Product Change Notification

Product Change Notification: P-16-012726

CE mark - suppliers address added

Samples of Changes

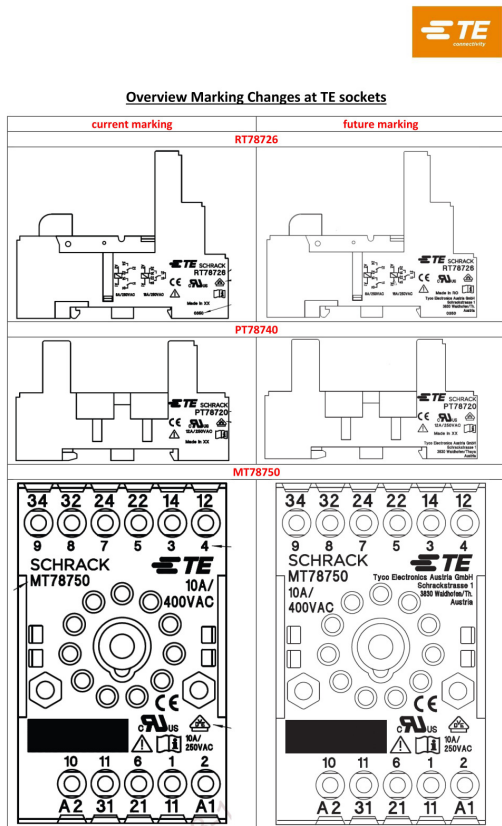
With the new Low-Voltage Directive it is necessary to add the suppliers contact address on either the product itself or on the packing. For this reason we will change the print resp. the label on the packing accordingly at all parts listed in this PCN. Enclosed you find also samples of the changes.
